Planning Department Transportation Development Services

Re: GAHH Relocation & Tenant Improvements, 4900 Menaul Blvd. NE

Certificate of Occupancy – Transportation Development

Re: GAHH Relocation and Tenant Improvements, Habitat for Humanity Restore, 4900 Menaul Blvd. NE, Traffic Circulation Layout -=

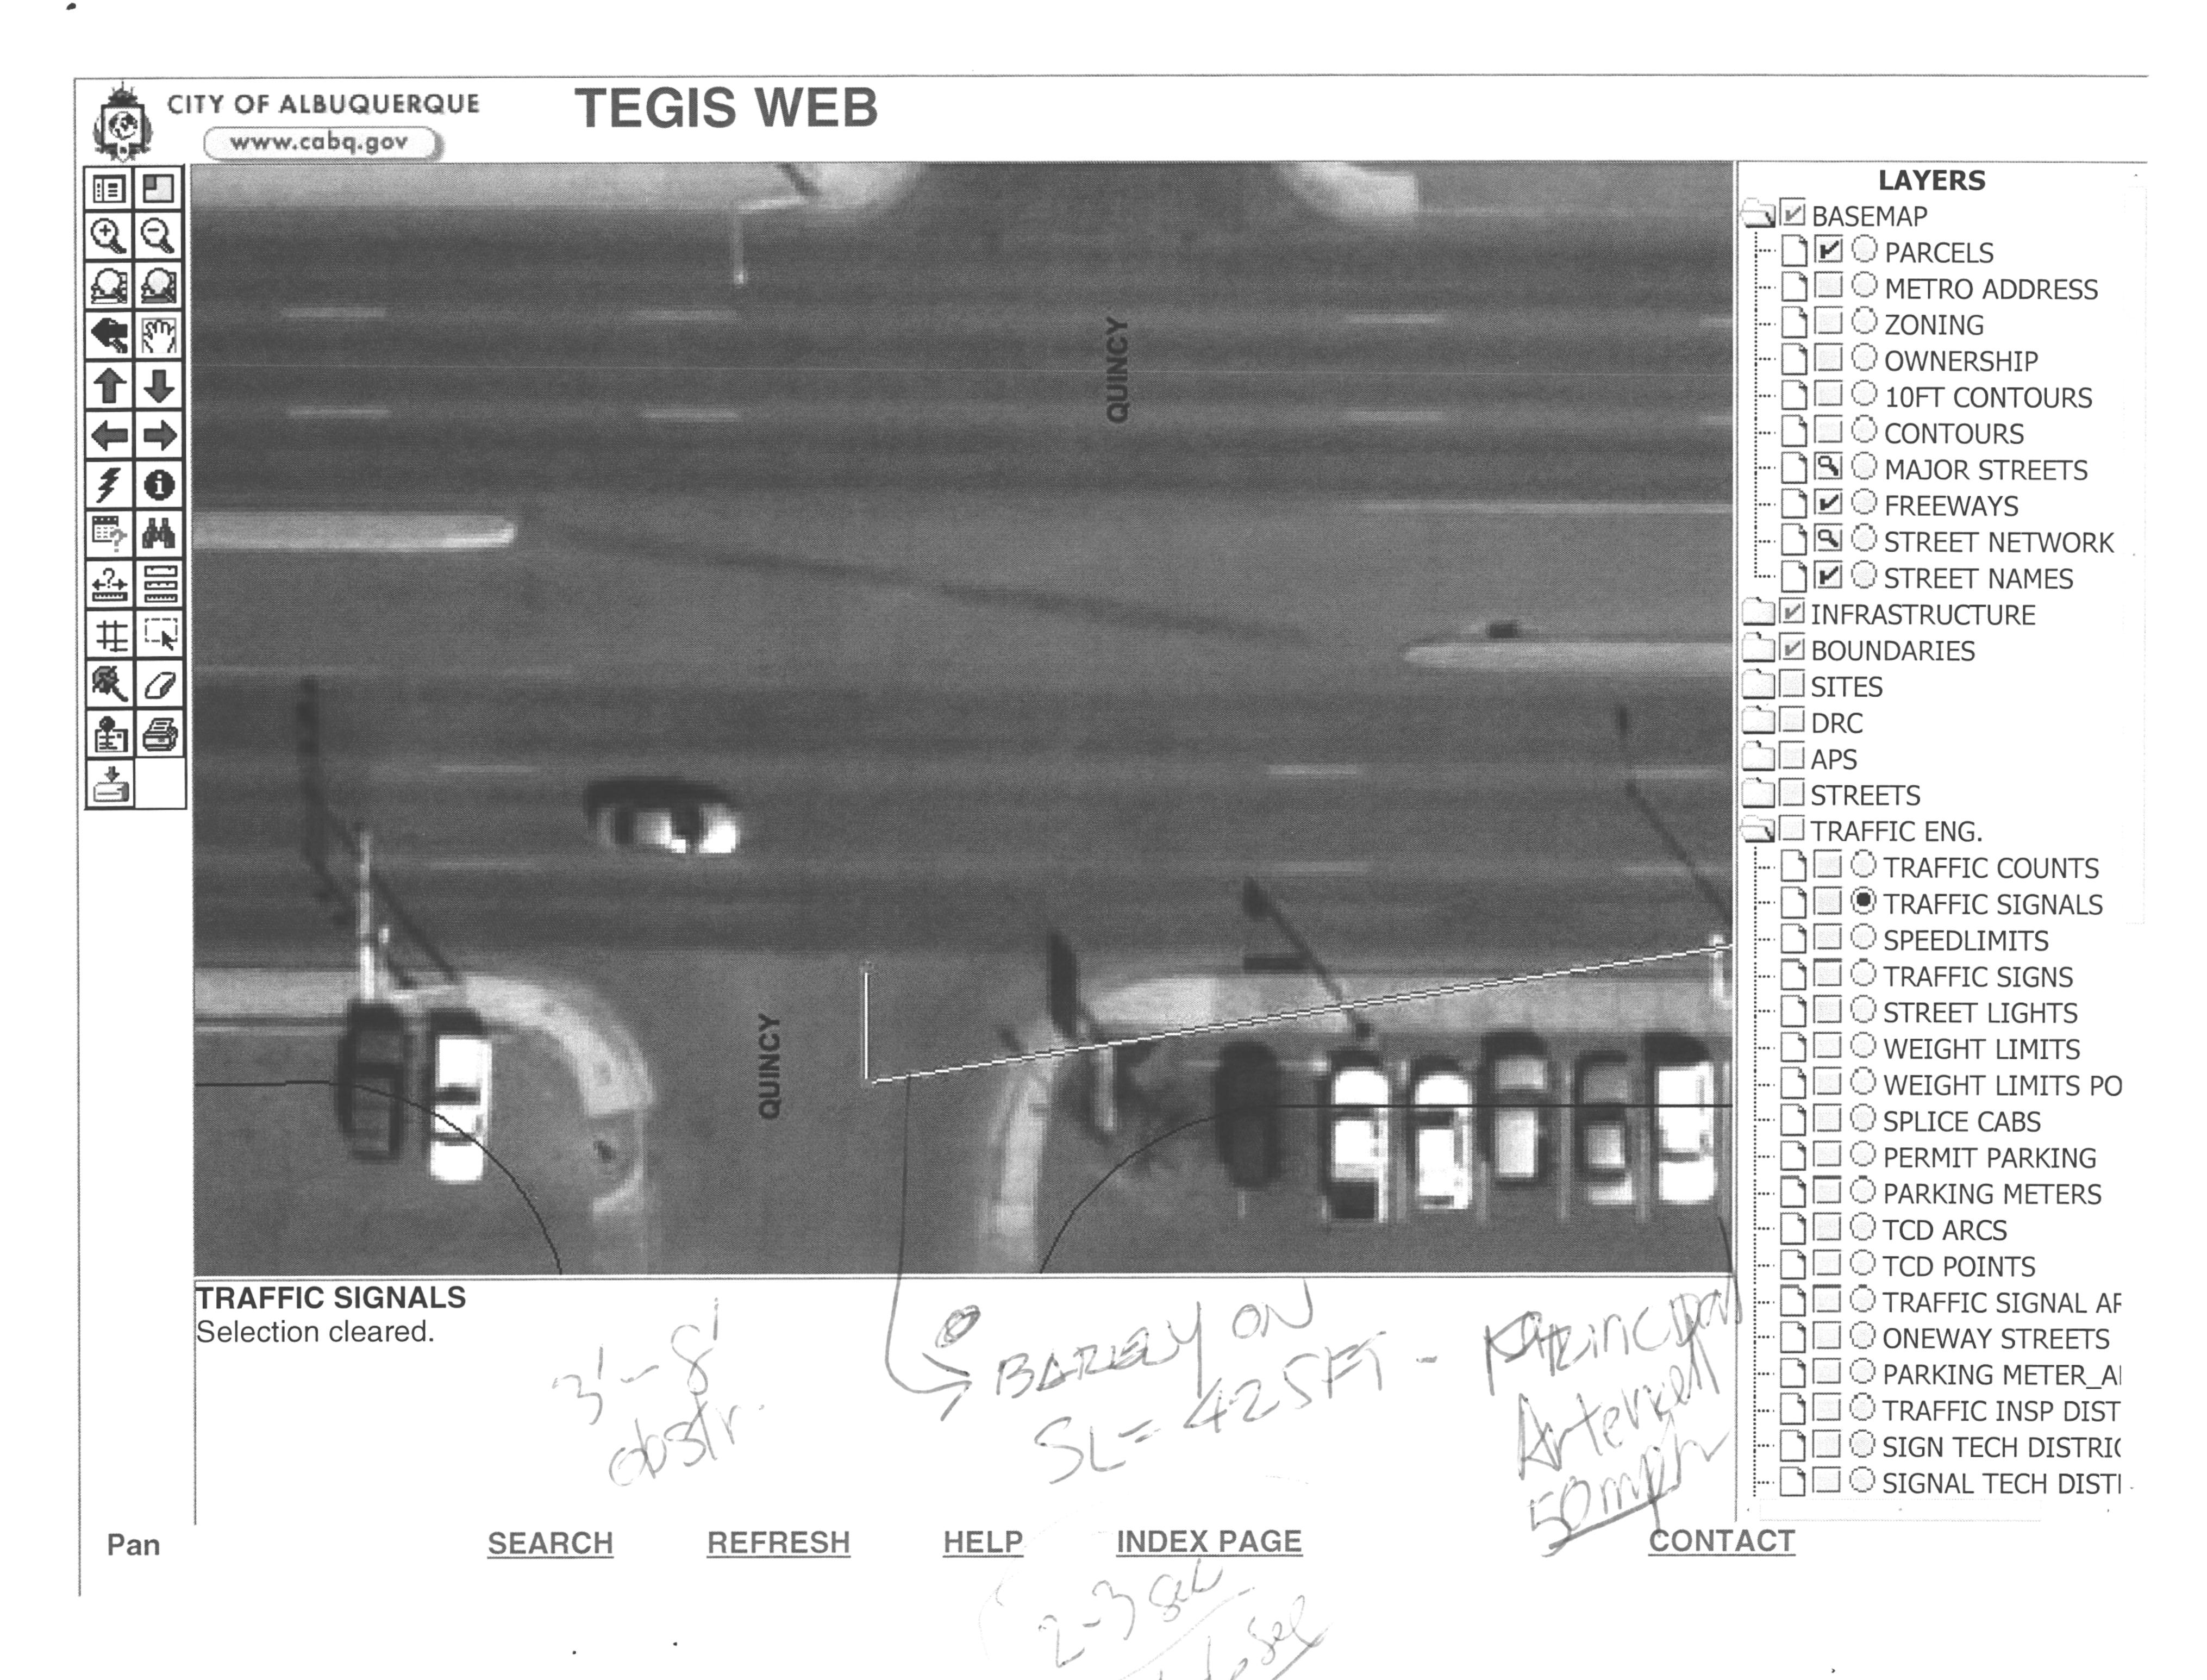
- The existing sign foundation is an obstruction for stopping sight distance and will need to be removed as stated on the approved TCL Site Plan dated 8/20/13.
- The existing parking bumpers, vehicle overhang, and street lights appear to be encroaching and/or located within COA ROW. These encroachments will need to be addressed.
